**ADOPTION OF IHO PUBLICATIONS**  
**S-100-BASED PRODUCT SPECIFICATIONS**  
**PHASE 1 – S-101, S-102, S-104, S-111, S-129**

**MEMBER STATES' RESPONSES TO IHO CL 39/2024 AND COMMENTS  
FROM THE WORKING GROUP and PROJECT TEAM CHAIRS, IHO SECRETARIAT**

<b>S-101, Ed. 2.0.0</b>	<b>Operational Product Specification</b>
-------------------------	--

Figure 4-10 – Dataset loading – scenario 4

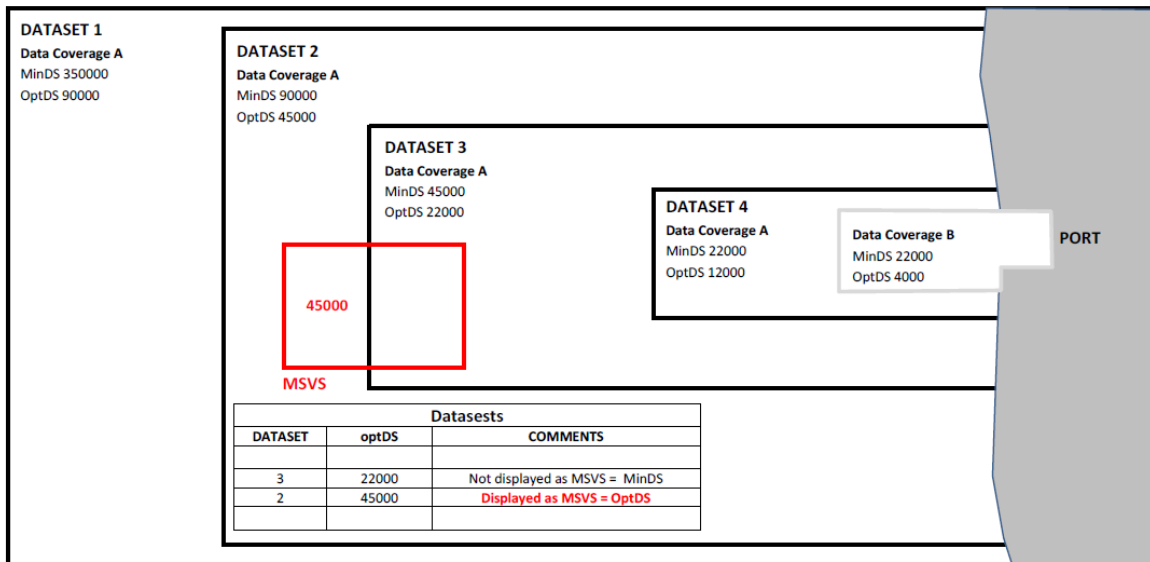
- 3) Product Specification - Add the attached Diagram to the end of Section 4.7.2 as a new Figure 4.10 and amend 2nd paragraph to read 'Figures 4-7 to 4-10 below are ...!'

Please note that all other Figures in the PS will have to increase their number by one.

These proposed changes have been agreed for correction (point 1) and clarification (points 2 and 3) as they enhance the guidance already included. The proposed new Figure 4-10 for the S-101 Main document has been included as Figure 4-9 as this is a better fit within the order of the Figures 4-7 to 4-10 in regard to Mariners' Selected Viewing Scale (MSVS). The changes have been applied for the final operational Edition 2.0.0 of S-101.
